ADDENDUM NO. 3

WL-100 AREA ELEVATED STORAGE TANK PROJECT

NORTHWESTERN WATER AND SEWER DISTRICT

DECEMBER 15, 2020

1. PLAN SHEET 1 OF 4—SITE PLAN

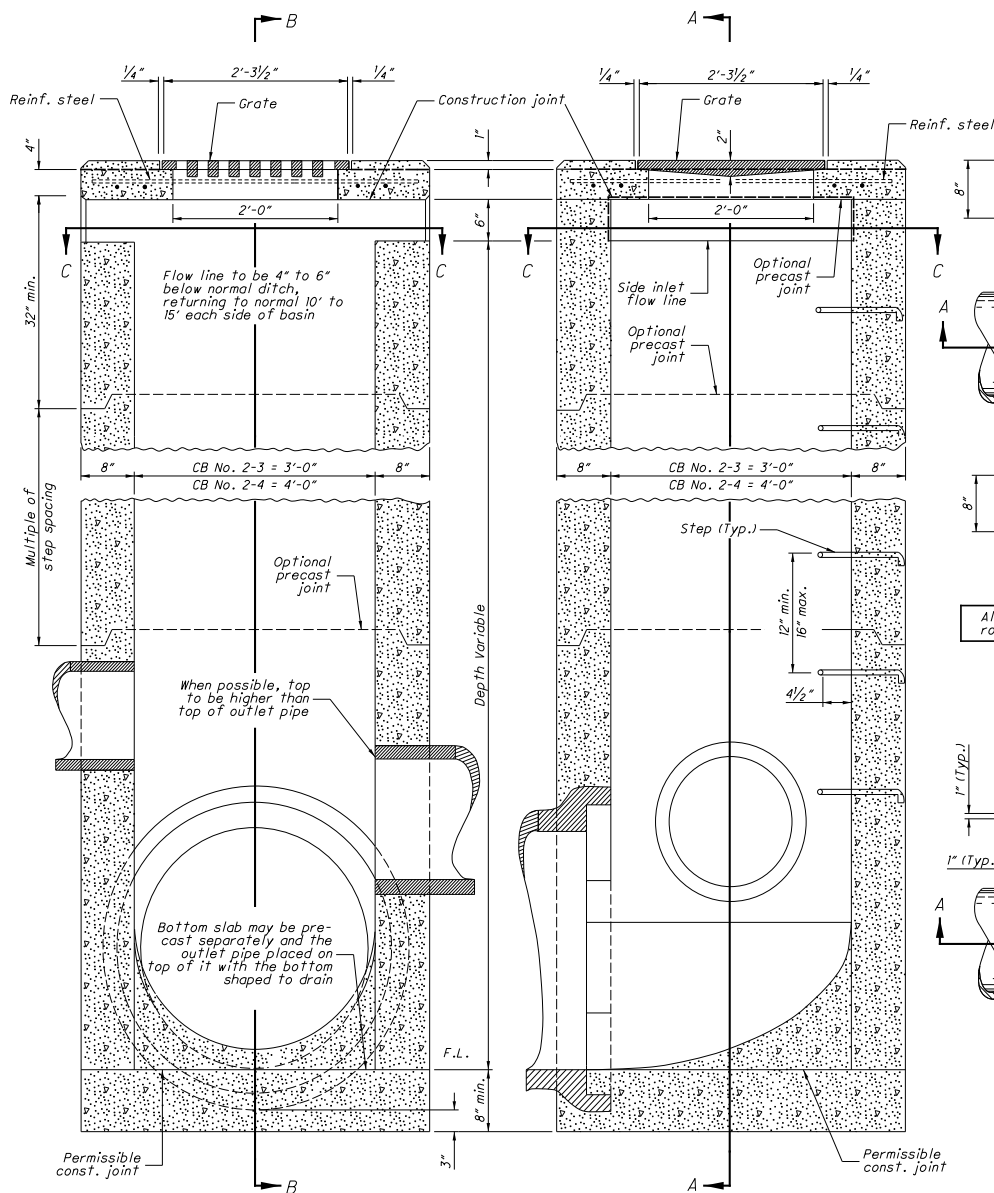
- a. Three catch basins shown as 2-2-B style basins, shall be changed to ODOT 2-3 basins. See attached ODOT Standard Drawing CB-1.2.
- b. The concrete drive pavement section shall be as shown on the attached detail.
